DESIGN PUBLIC HEARING

COMMENTS AND RESOLUTIONS FOR BEACON STREET PROJECT

Patricia Leavenworth, PE., Chief Engineer
MassDOT - Highway Division
10 Park Plaza
Boston, MA 2116-3973

Project file #: 607209
Beacon Street
July 15, 2013

Intersections

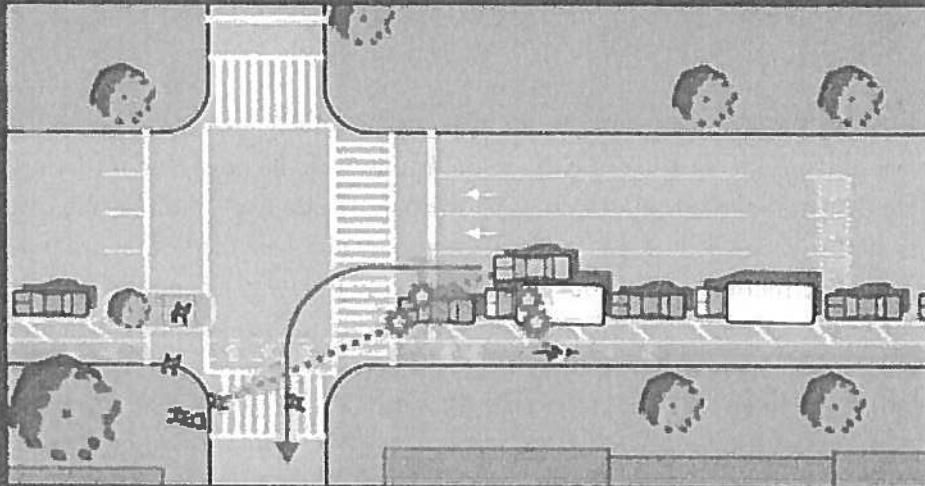
In its review of the Design Exception Report, MassDOT rightly pointed out that “Cycle track design at driveways and side streets is vital for bicyclist safety and comfort. Poorly designed treatments may lead to decreased safety.” The relevant design guidelines spell out why it is very difficult to reduce intersection conflicts between cyclists on a sidewalk or sidepath and motorists on the roadway. The current AASHTO GDBF says: When approaching an intersection, drivers focus their attention in certain specific directions, depending on the planned maneuver through the intersection. If planning to turn left from the parallel roadway, drivers focus their attention ahead to watch for a gap in oncoming traffic and to the left to watch for potentially conflicting

traffic on the side road. When turning right from the parallel roadway, drivers focus their attention ahead and to the right, as this is the direction from which they expect conflicting traffic. When turning onto the parallel roadway (or crossing the parallel roadway) from a side road or a driveway, drivers almost exclusively focus on traffic approaching from the left, in order to look for a gap and to avoid conflicting traffic. Sidepaths, especially two-way sidepaths, insert path users into intersections at locations that do not match with the ingrained scanning behaviors of motorists, which can in effect create virtual “blindspots” even in locations with no actual restrictions on sight distance or visibility. For example, a driver turning left from the parallel roadway across the sidepath might do a very conscientious job of looking for potentially conflicting traffic from the parallel road and crossroad, but completely miss a path user approaching from behind and to the driver’s left, a location from which a driver is not conditioned or trained to expect conflicting traffic. It is nearly impossible for a driver turning left from the parallel roadway across the sidepath to accurately monitor the presence, location, or speed of sidepath traffic approaching from behind and to the left without compromising the ability to look for potential conflicts from other directions. Similar mismatches between scanning behavior of roadway traffic and arrival locations of sidepath traffic can be found with right turns from the parallel roadway and movements from the crossing roadway. On multilane streets with higher speed limits, the situation can be more challenging, due to narrowing field of vision, shorter reaction times, and the screening effect of other traffic in adjacent lanes. Sidepath users typically take their right of way cues from either the pedestrian signalization or the signals controlling the parallel roadway. Path users typically enter the intersection when the parallel roadway has a green indication. Some path users, mainly pedestrians, observe the pedestrian signal and enter under the Walk phase, but bicyclists often continue to enter and cross the intersection well into the “DONT WALK” phase. Conflicts between roadway traffic and sidepath users can be complicated by the perception among some path users that turning and crossing drivers will yield to sidepath traffic when the path user has the right of way (e.g., when given a green signal or “WALK” signal) and the potentially conflicting vehicle is visible to the path user; however, due to scanning patterns, the vehicle driver may not look in the direction of the path user. Conventional signalization may not be effective in mitigating these conflicts.”

Protected Bicycle Path Mixing Zone

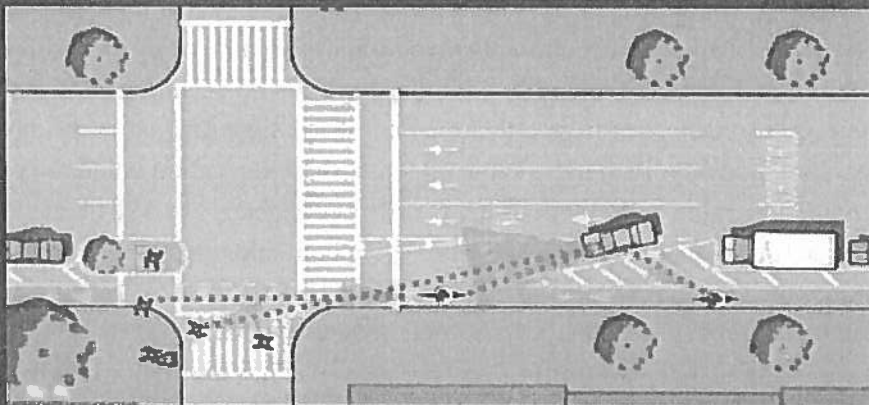
The first figure above illustrates that an urban bike path behind parked cars is “potentially deadly” because turning drivers cannot see bicyclists until it is too late. The second figure shows New York’s solution: provide a “mixing zone” of 100 feet in length that has no parked cars, clear sight lines, a short left-turn only lane, and a yield line for left-turning cars (this could equally be a right-turn only lane if it were on the right side of the street).

Response: The guidance from New York is for left-side bike lanes, in which the driver of a car in a lane adjacent to the bike lane has a much reduce angle of sight (because he / she is sitting so close to the bike lane) compared to a right-side bike lane. The proposed cycle tracks will be on the right side of their respective side of the road.

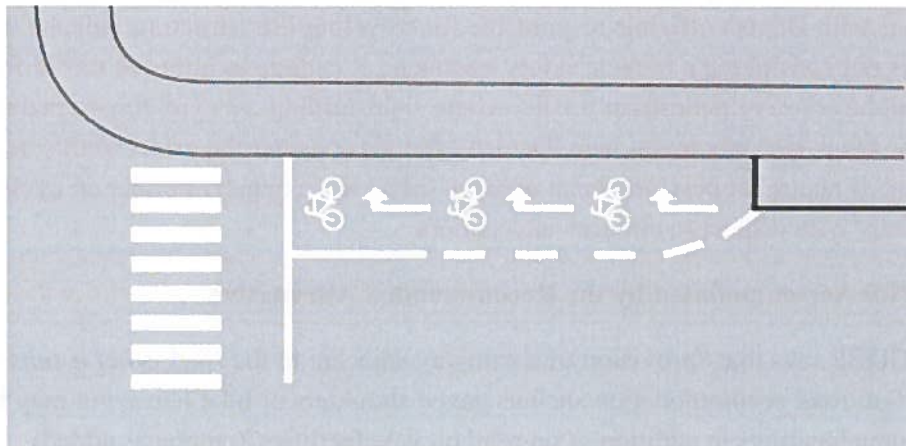
Another Danish design is similar to New York’s mixing zones: “interrupt the bicycle path 15 to 25 meters [50 to 75 feet] before the stop line and let the cyclists continue in a right-turn lane, together with the right-turning traffic. This solution lets straight-through cyclists and right-turning motorists merge together before the intersection, which reduces the risk of accidents. The stretch up to the stop line is marked as a right turn lane with a bicycle symbol.”(See figure below, taken from the same source.)

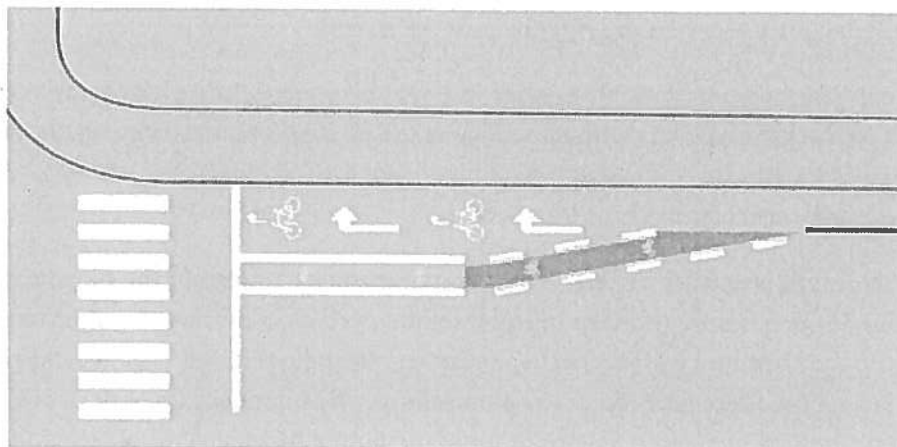
The Danes also provide another option; “The shortened cycle path can be combined with a bike lane between the straight and right-turn lanes for the straight-through and left-turning bicycle traffic.”(See figure below.)

Response: The commenter cites the Danish treatment of transitioning the cycle track to a bicycle lane. Discussions with Danish officials responsible for bicycling infrastructure indicate that in Denmark, this is not considered a bicycle safety treatment; it is done to improve traffic flow at intersections that have heavy pedestrian traffic, where right-turning cars yielding to pedestrians would otherwise block the only travel lane. Danish officials consider the effect of this treatment on bicycle safety as neutral at best, and acknowledge that it has a negative effect on cyclist comfort, especially with respect to children and seniors.
